EAST NETHERSHIELDS ROAD SAFETY REVIEW OF TIMBER EXTRACTION JUNCTION

ROAD SAFETY REVIEW
(SPA Ref No: 5564)

Roads Authority: South Lanarkshire Council

Client: Tilhill

Northbound view of location of the slight injury collision on 16 July 2020

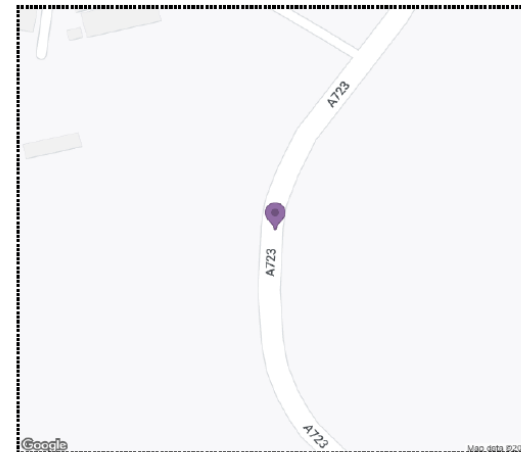
- 6.7 The collision that occurred on 16 July 2020 between the two access junctions for Nethershields Farm appears to be related to two opposing vehicles colliding at the bend in the carriageway. It is assumed that there has been a loss of control where crossing of the centre line has occurred.

Southbound view of location of the serious injury collision on 13 October 2022

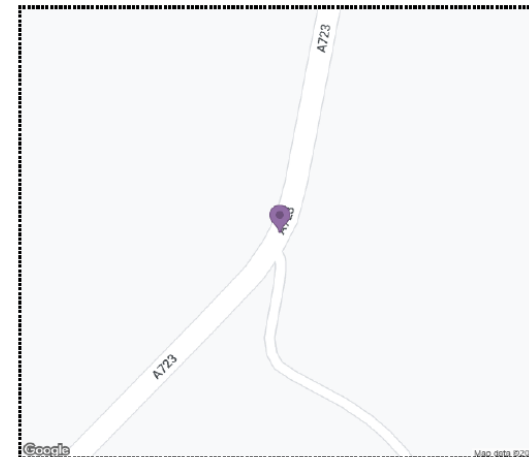
- 6.7 The serious collision directly to the north of the access junction on 13 October 2022 appears to be the result on a collision involving turning traffic at the junction that leads to Shotlinn Farm.
